MEMORANDUM

Location: O. S Grid Ref: 485 394 Land North of Oakfield Close, Bronington, Wrexham.

Development: Erection of 5 no. dwellings including associated garages, amenity space and access arrangements.

I refer to your consultation dated 12/08/2019 including layout plan (Drg. No. MR_003 Rev B) in respect of the above.

Turning Areas

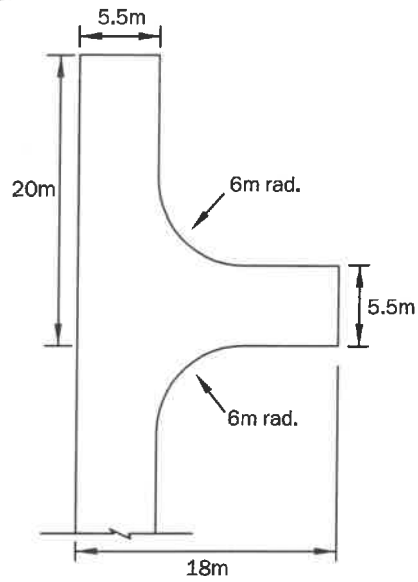
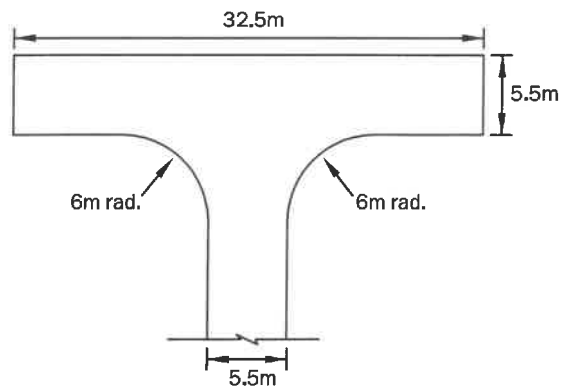
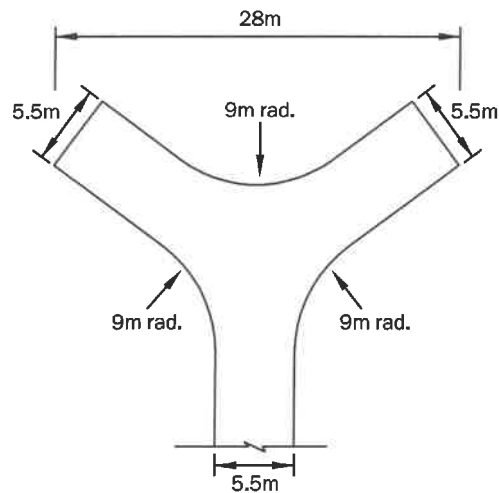
The proposed turning head indicated on the submitted layout plan is not compliant with WCBC adoptable standards and cannot accommodate the turning movements of an 11.2m long refuse vehicle. Manual for Streets recommends a maximum reversing distance of 12m for refuse vehicles. **I would recommend that the applicant submits a revised layout plan indicating the provision of a turning head compliant with WCBC Standard Details (see attached detail).**
